**Metropolitan Branch Trail
ANC 4B Public Works and Infrastructure
Committee**

**Response to questions submitted by ANC 4B Public Works and Infrastructure
committee**

Updated December 2017

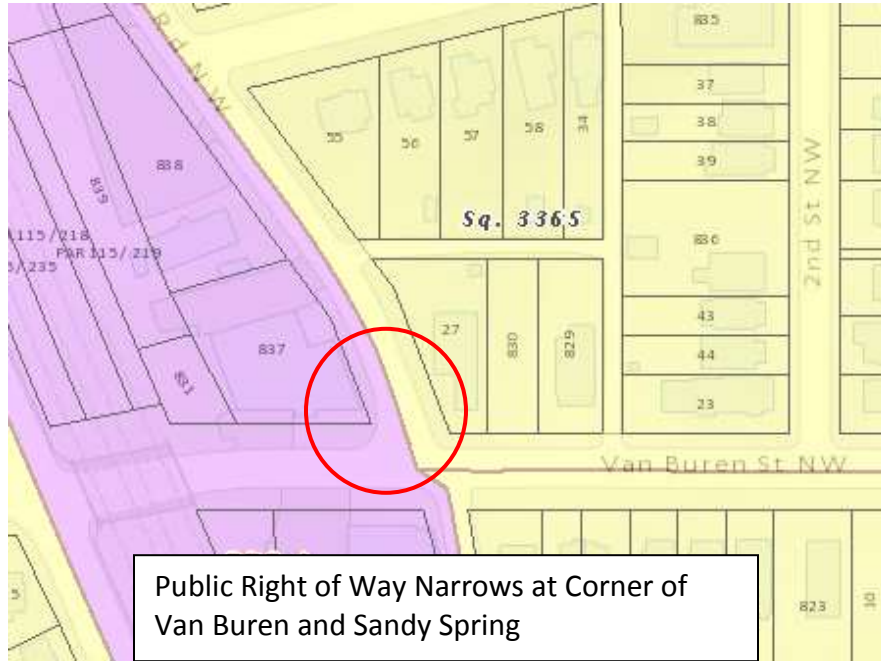
- 2. What is the estimated volume of traffic through the Aspen Street/Blair Road intersection? -- both during rush hour and outside of rush hour? – (once the following facilities are built and in operation: DCI school, the large apartment building at the corner of Aspen and Sixteenth, the recreational facilities in and around Walter Reed's former power plant, the art facilities along Cameron Drive, the three large apartment and condo buildings (V/U) with first floor retail in the building at the corner of Aspen and Georgia, events held on the Great Lawn.)**

The estimated Annual Daily Traffic of Blair Rd at Sheridan St NE is 15,000 vehicles. The impacts of the proposed trail on rush hour traffic were analyzed using a traffic model. The results of the

model indicate that the proposed trail and one northbound lane approach of Blair Rd at Aspen St meet an acceptable level of service. While there will be minimal delay for motor vehicles, there will be benefits to pedestrians and bicyclists from the addition of the trail.

The traffic analysis utilized projected future traffic volumes in 2040, which include trips due to adjacent new development (such as Walter Reed) and other increases in vehicle volumes due to overall regional growth. The table above shows the “Level of Service” (which is a quantitative measure of traffic flow on a scale of A to F) at the intersection of Aspen and Blair. The table also shows the delay in seconds per vehicle under the existing conditions and expected conditions based on the traffic model.

We expect the majority of trips traveling to the new development at Walter Reed to access the site via Georgia Ave. Additionally, trips to the site coming from the east or via Blair Rd are expected to utilize Butternut St to travel east-west. Butternut is a collector street that goes directly into the new development at Walter Reed. It is a wider street designed to carry a higher volume of traffic. Aspen is a local street and does not provide direct access into the site. The traffic model estimates that a small amount (<5%) of traffic will divert to Missouri/5th St NW and Kansas/Eastern Ave NE. However, the current design of the trail will not preclude the addition of a left turn lane at Aspen St if necessary to mitigate future increases in vehicular delay
